Product Change Notification

Change Notification #: 106443 - 00
Change Title: SC5299-E, PCN 106443-00, Product Design, Class 2, Front Panel Board Thermal Sensor Reliability
Date of Publication: June 16, 2006

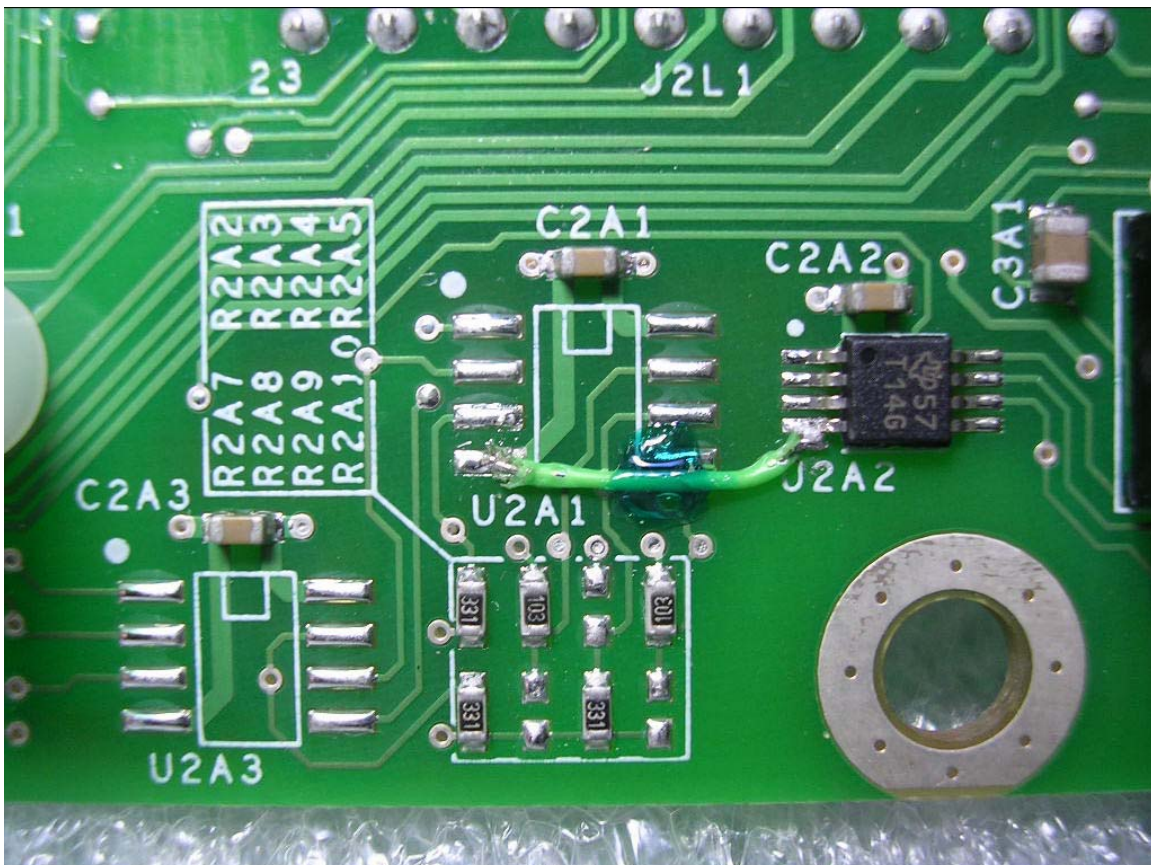
A wire (diameter=0.5mm) is being added to the front panel board to increase front panel thermal sensor reliability. This wire will run between Pin4 of U2A2 and GND (Pin4 of U2A1).

The Front Panel Board P/N will also change from D23494-302 to D23494-303.

The customer will notice a jumper wire has been added to the Front Panel Board. Standard customer validation testing is recommended.
